Re: Fourth Submission Review – DA 2170-07 – Stafford Logistics Center Commercial – Master Plan  
Amendment, Infrastructure Site Plan, and Plat.  
Application Number: DA-2170-07  
Case Numbers: 2024-3001-00; 2019-7001-04; 2024-6002-00

# STAFFORD LOGISTICS CENTER - COMMERCIAL SITE

## INFRASTRUCTURE SITE PLAN

STAFFORD LOGISTIC CENTER  
SITE PLAN  
OVERALL SITE PLAN  
AURORA, COLORADO

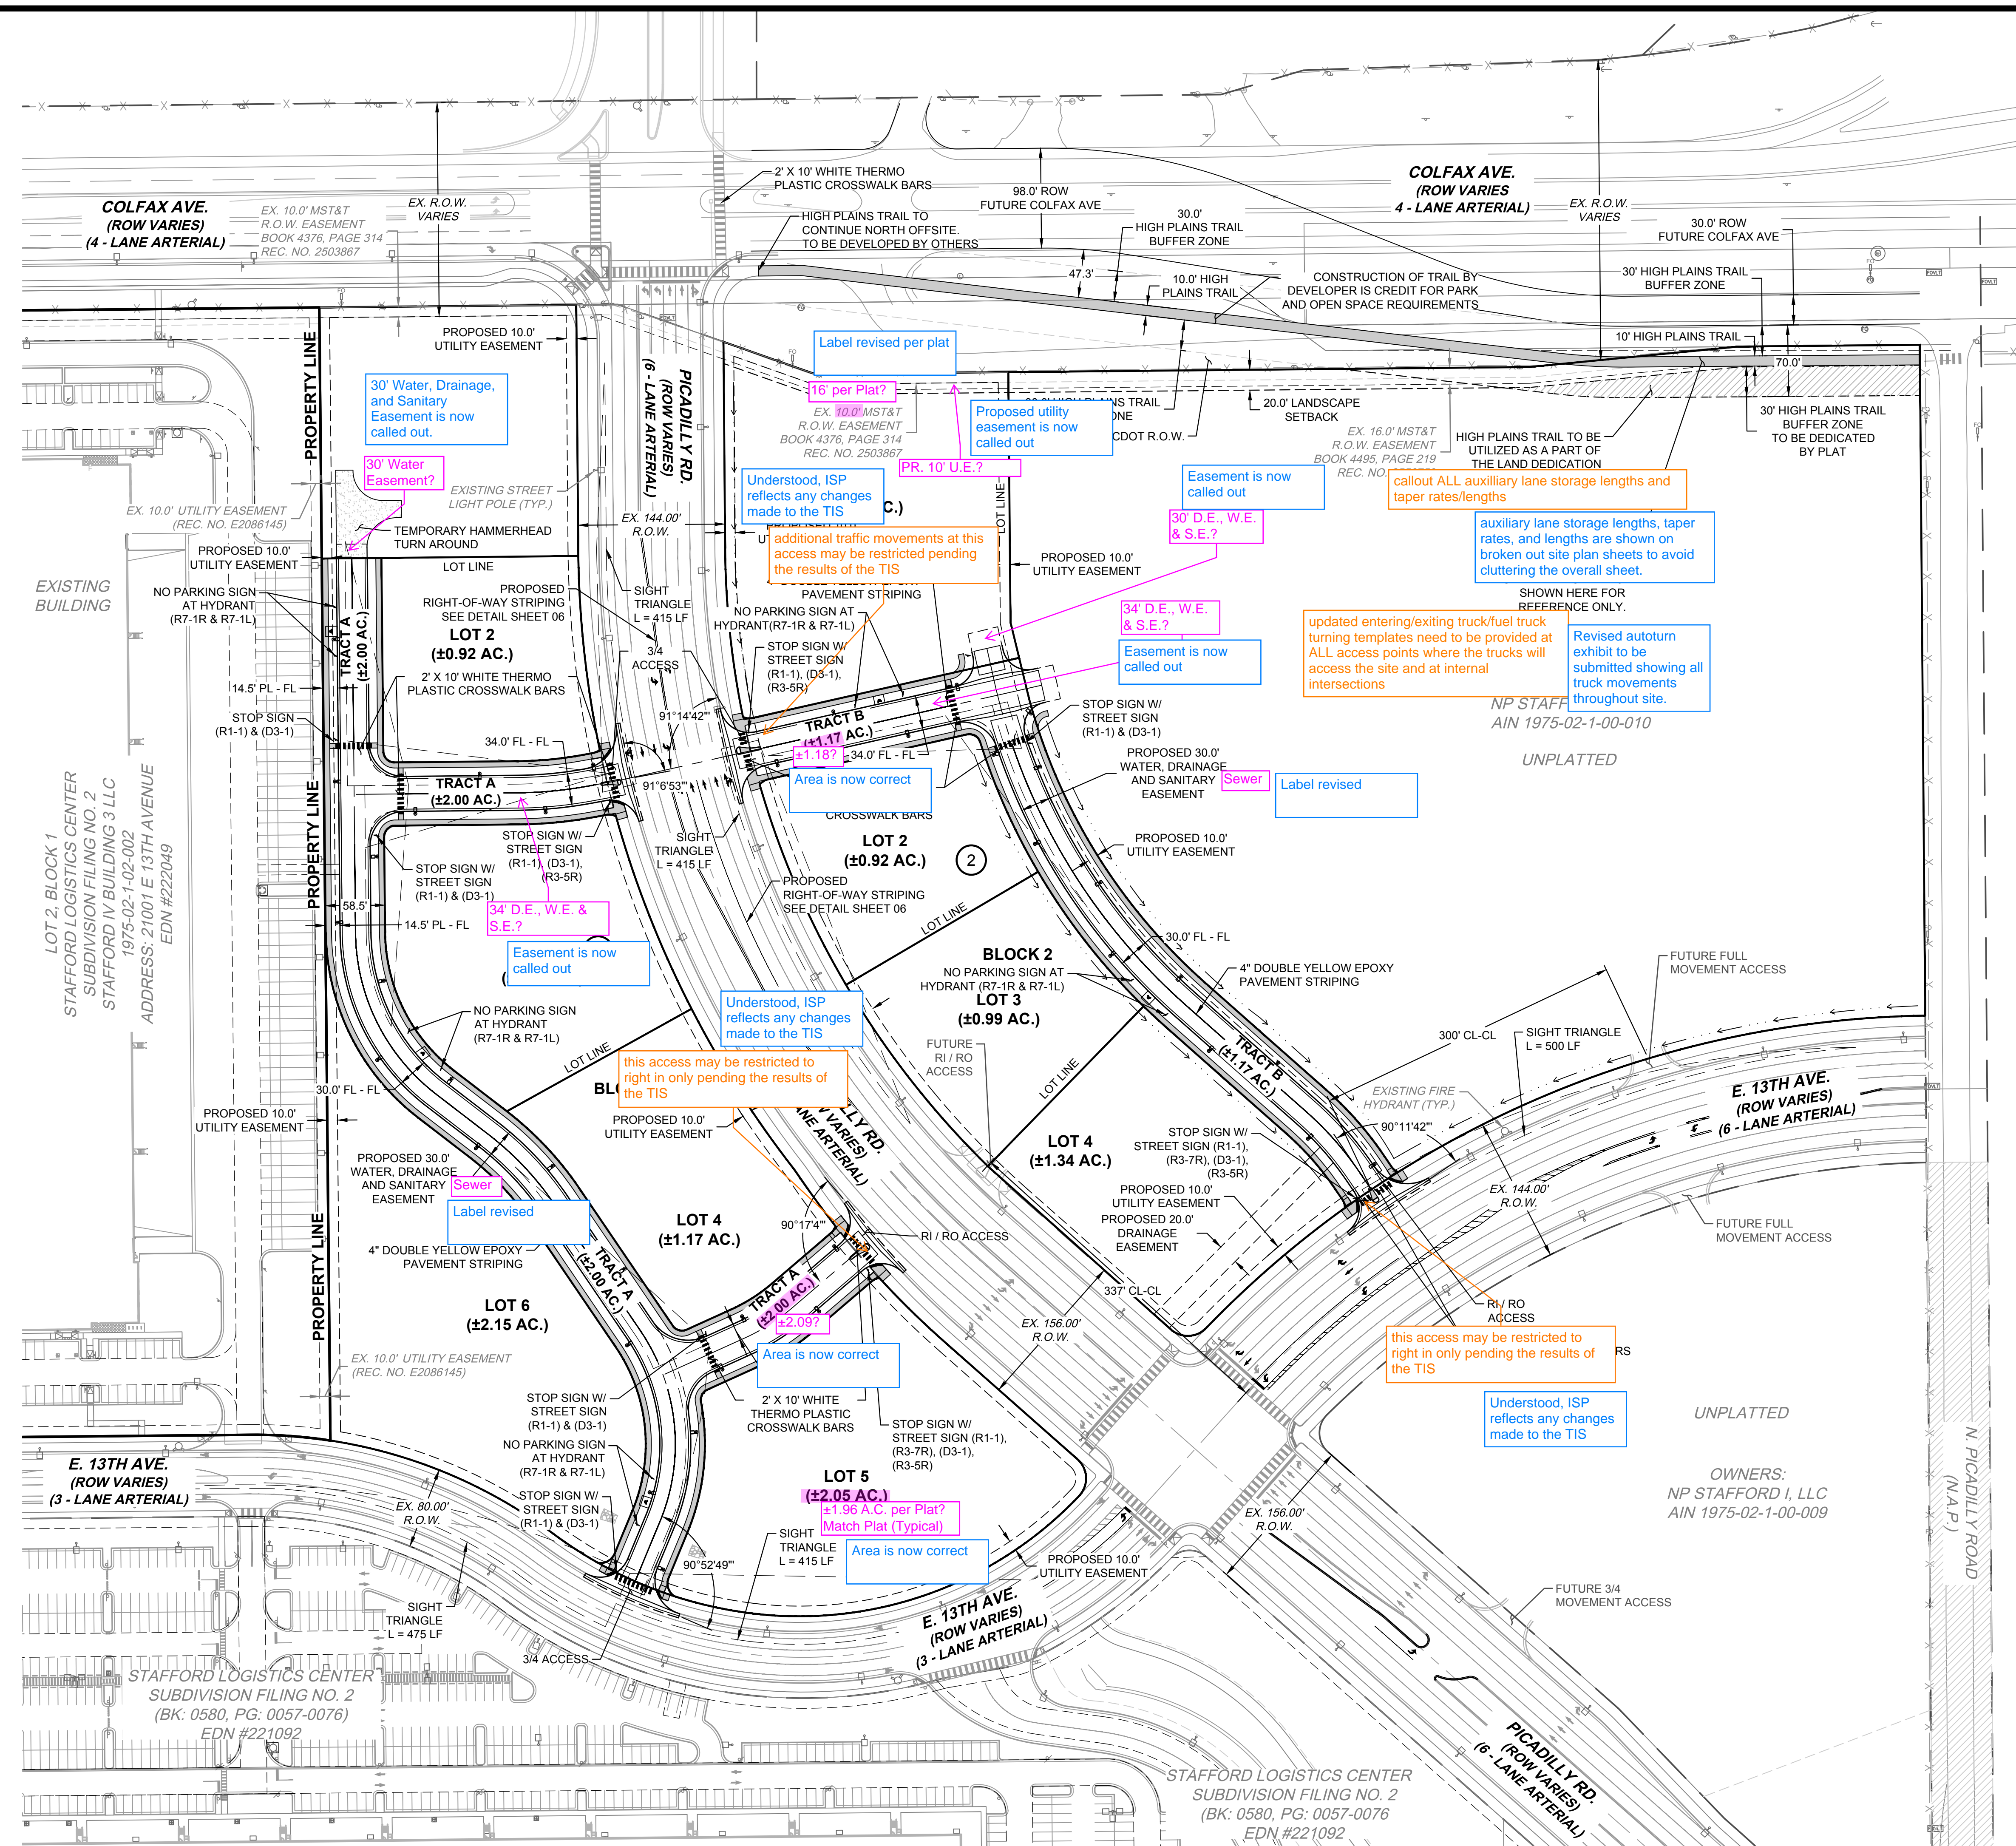
- 5EE. Sheet 2: Callout ALL auxiliary lane storage lengths and taper rates/lengths.

- 5FF. Sheet 2: Updated entering/exiting truck/fuel truck turning templates need to be provided at ALL access points where the trucks will access the site and at internal intersections

- 8F. Sheet 2: Label easements to match the plat and match easement names with the plat.

- 8G. Sheet 2: Revise the acreage to match the plat.

**WM Response: Auxiliary lane storage lengths, taper rates, and lengths are shown on broken out site plan sheets to avoid cluttering the overall sheet.**

**WM Response: Revised autoturn exhibit to be submitted showing all truck movements throughout site.**

[WM Response: Easements relabeled to match plat.](#)

[WM Response: Acreages are now consistent with plat.](#)

Sheet 04 of 30

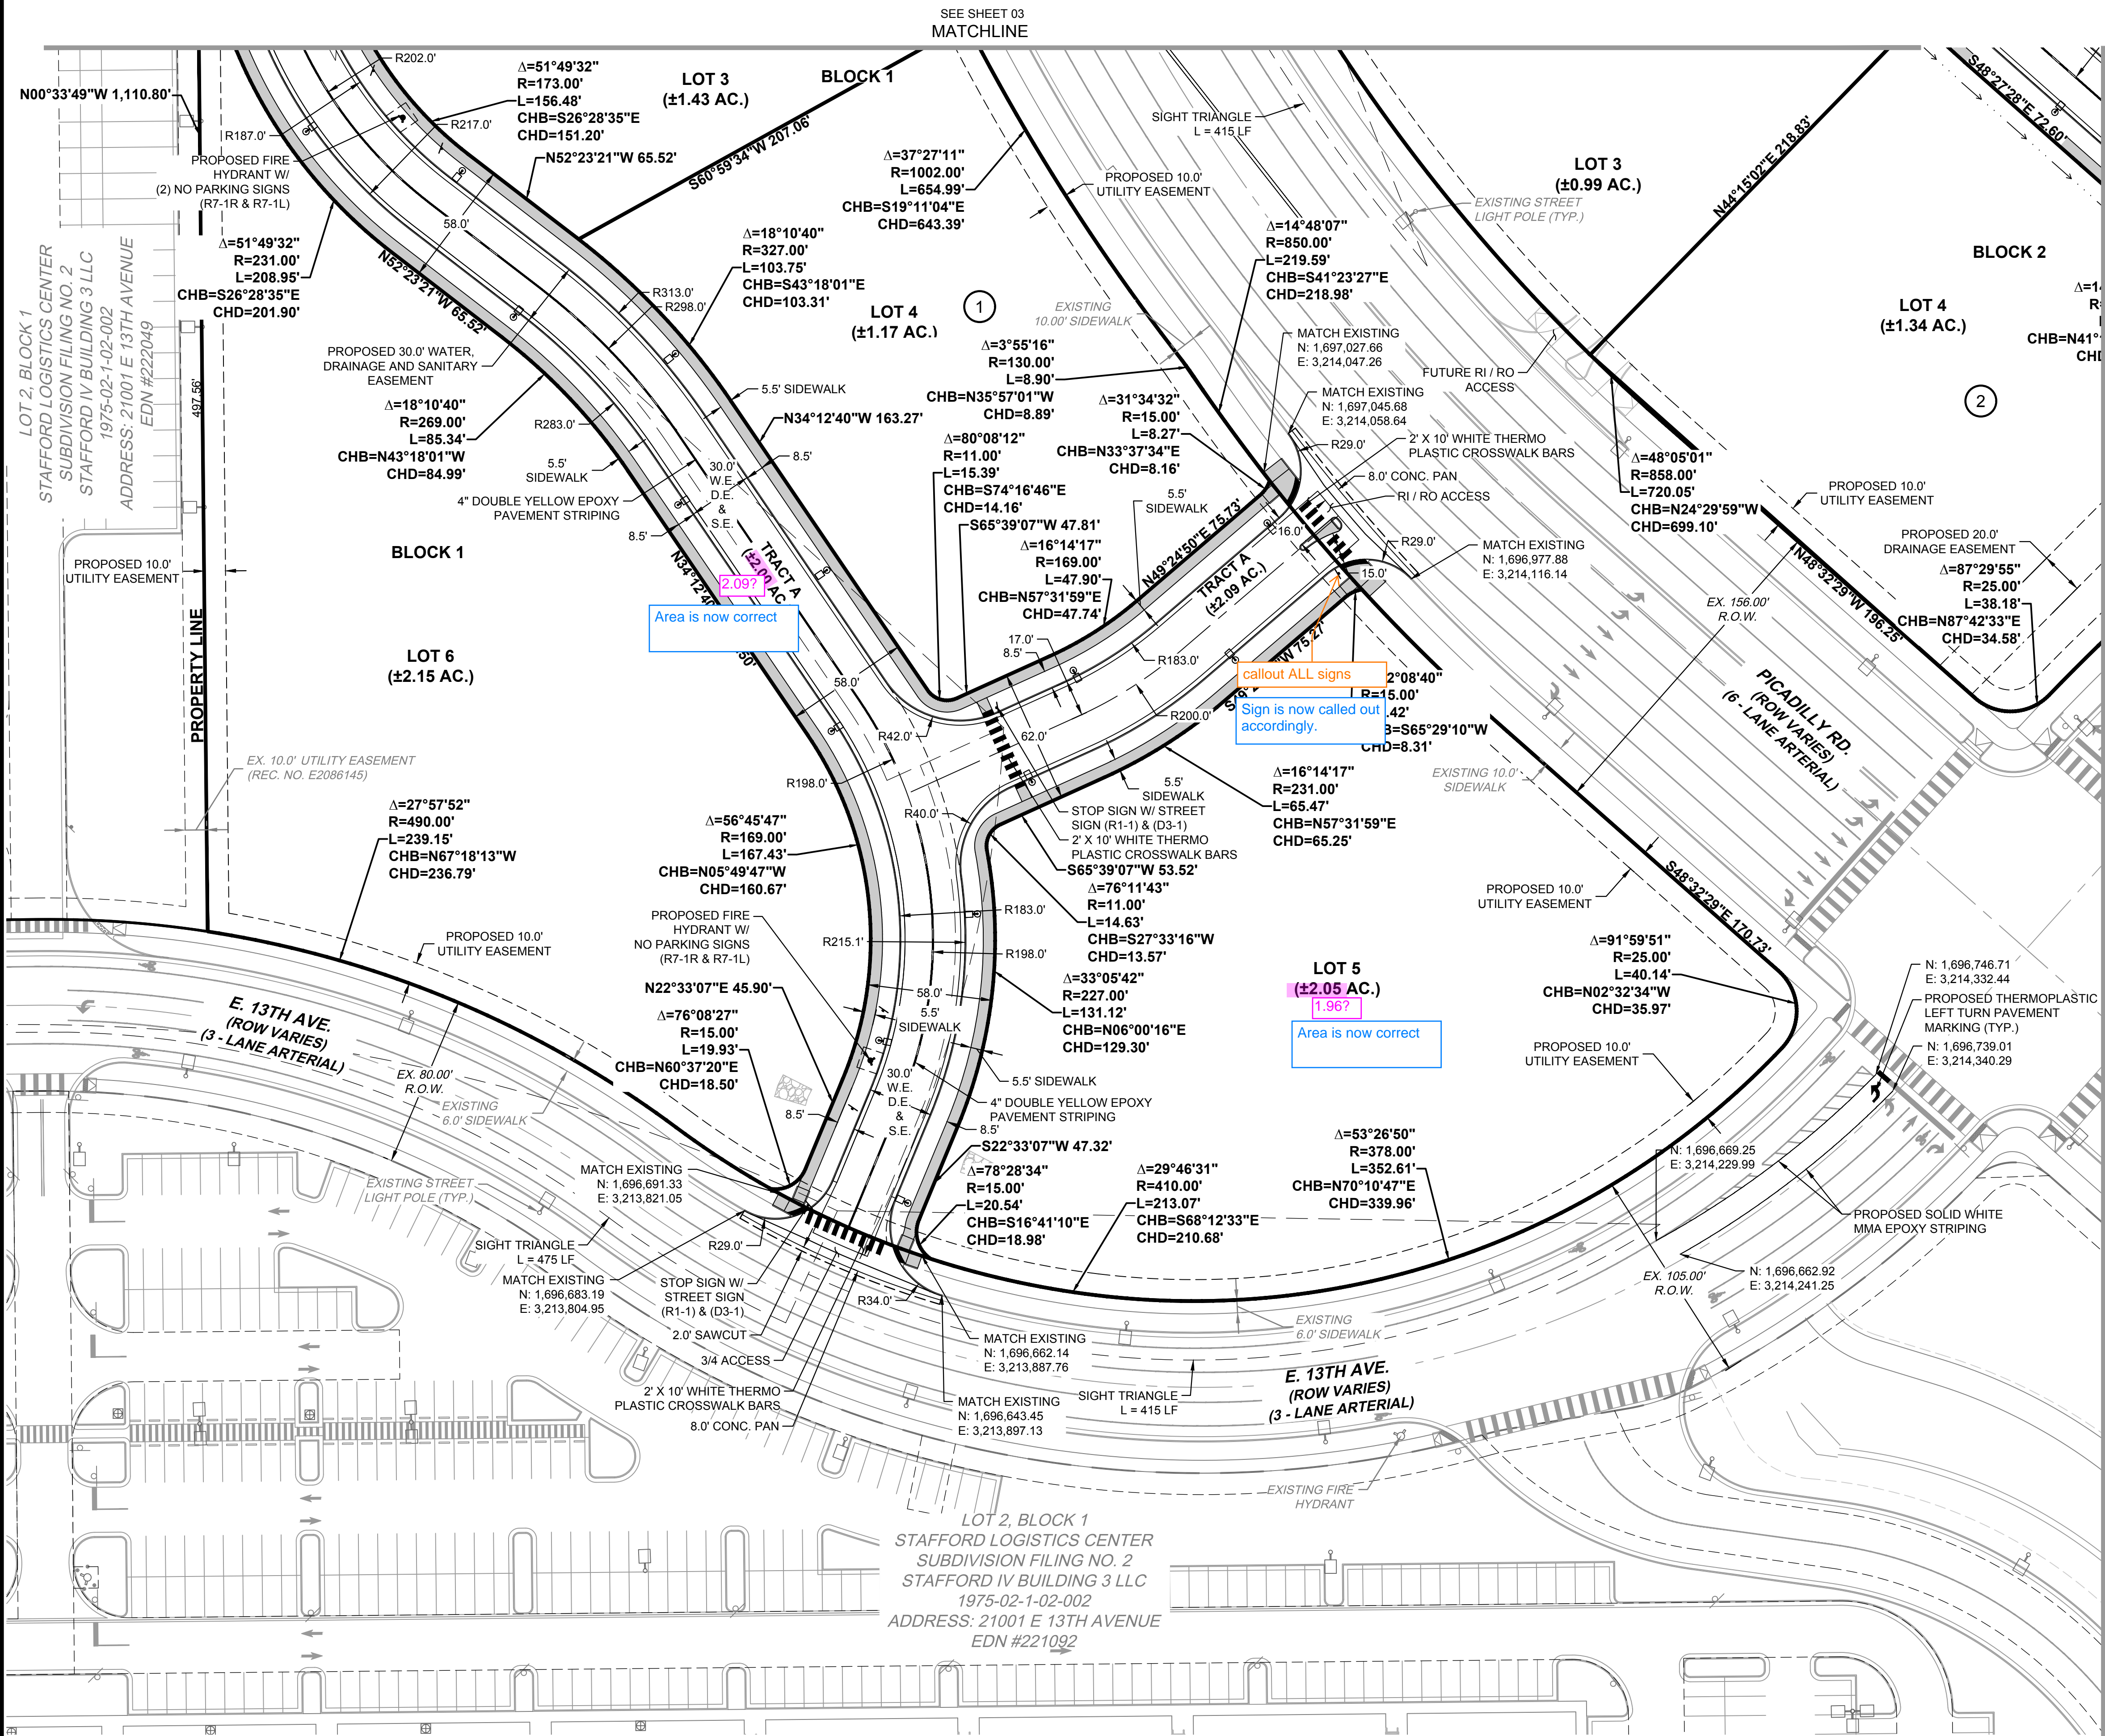
- 5LL. Sheet 4: Callout all signs.

- 8K. Sheet 4: Revise the acreage to match the plat.

**WM Response: Sign is now called out accordingly.**

[WM Response: Acreages are now consistent with plat.](#)
